SUBJECT: Requests hydrostatic testing of identified Inservice Inop
 Class 1 & 2 piping at lower pressures than 1974 ASME Code
 criteria. Avoidance of unnecessary personnel exposure to
 radiation hazards cited. Fee paid.

February 3, 1986
AEP:NRC:0070V

Donald C. Cook Nuclear Plant Unit No. 2
Docket No. 50-316
License No. DPR-74
INSERVICE INSPECTION PRESSURE TEST - CODE RELIEF

CODE RELIEF
4

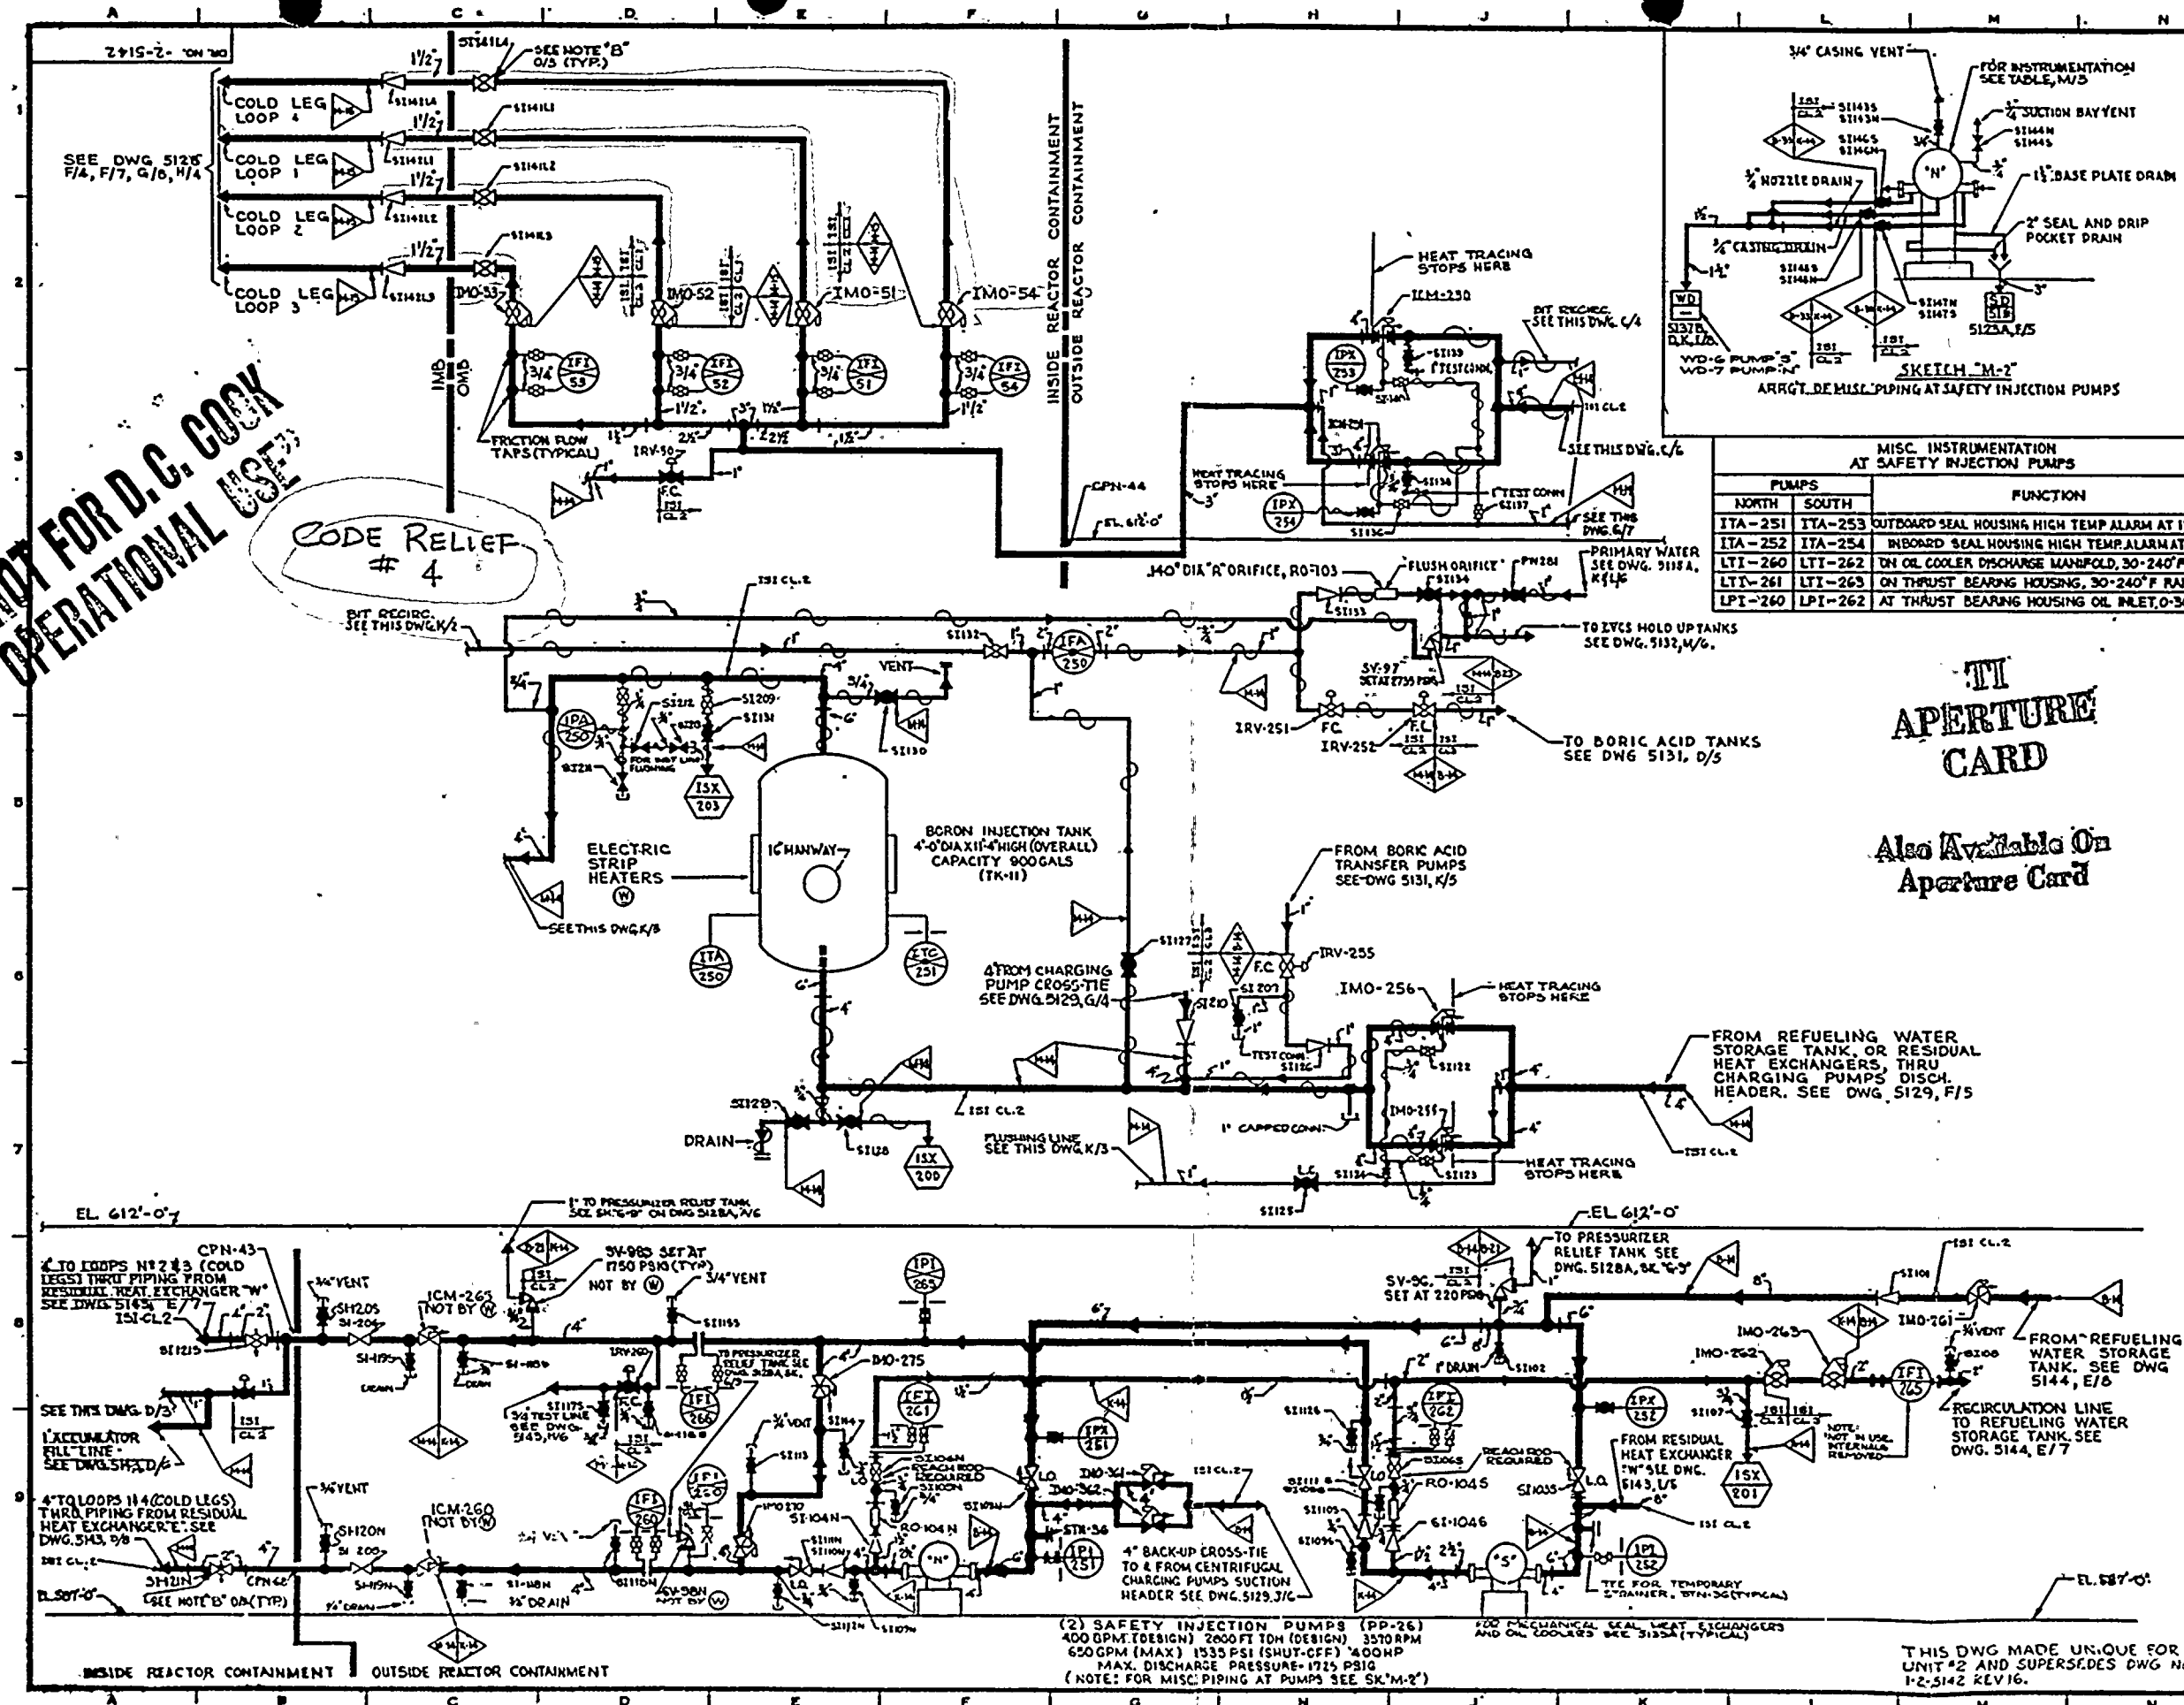
4. Emergency Core Cooling System (SIS), Drawing 2-5142 (Attached)

Valves IMO-51, SI-142L1 - Boron Injection Loop No. 1
Valves IMO-52, SI-142L2 - Boron Injection Loop No. 2
Valves IMO-53, SI-142L3 - Boron Injection Loop No. 3
Valves IMO-54, SI-142L4 - Boron Injection Loop No. 4

For an operating pressure of 2235 psig, Article IWB-5000 of the ASME Code, Section XI, requires that the piping be tested at a pressure of 2458 psig and a temperature not less than 100°F.

We propose to test the above section of piping at a pressure of 2280 psig and a temperature above 100°F. The test will be performed during Mode 3 with the RCS pressure at 2280 psig and \geq 500°F. The RCS pressure will be used to block check valves SI-142L1 through L4 closed, thus limiting maximum pressure at 2280 psig.

This is a similar situation to Relief Request No. 1. The sections of the piping system upstream of check valves SI-142L1 through L4 cannot be tested at a pressure 2458 psig without making temporary modifications (blocking the valve disc) to keep

the check valves closed. Since the piping sections are part of the primary system, plant personnel would be subjected to substantial radiation exposure and contamination in order to carry out such modifications for the test.

We believe that this is a reasonable code relief request, since the proposed test pressure is in fact higher than the 2235 psig nominal operating pressure in the sections of piping, each approximately 44 to 55 feet long, for which code relief is requested.
